E/ECE/324 | Rev.1/Add.50/
E/ECE/TRANS/505 | Amend.3
6 May 1992

Addendum 50: Regulation No. 51

Amendment 3

UNIFORM PROVISIONS CONCERNING THE APPROVAL OF MOTOR VEHICLES HAVING AT LEAST FOUR WHEELS WITH REGARD TO THEIR NOISE EMISSIONS

Figure 3

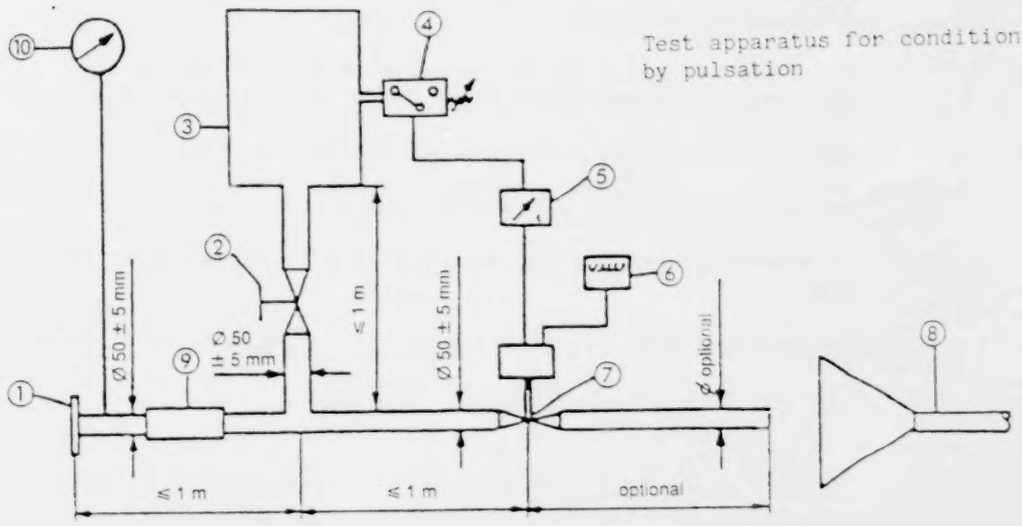
Add the following new figure 3 to the appendix of this annex.

Test apparatus for conditioning by pulsation

1. Inlet flange or sleeve for connection to the rear of the test exhaust system.

2. Hand-operated regulating valve.

3. Compensating reservoir with a maximum capacity of 40 l and a filling time of not less than one second.

4. Pressure switch with an operating range of 0.05 to 2.5 bar.

5. Time delay switch.

6. Pulse counter.

7. Quick-acting valve, such as exhaust brake valve 60 mm in diameter, operated by a pneumatic cylinder with an output of 120 N at 4 bar. The response time, both when opening and closing, must not exceed 0.5 second.

8. Exhaust gas evacuation.

9. Flexible pipe.

10. Pressure gauge.
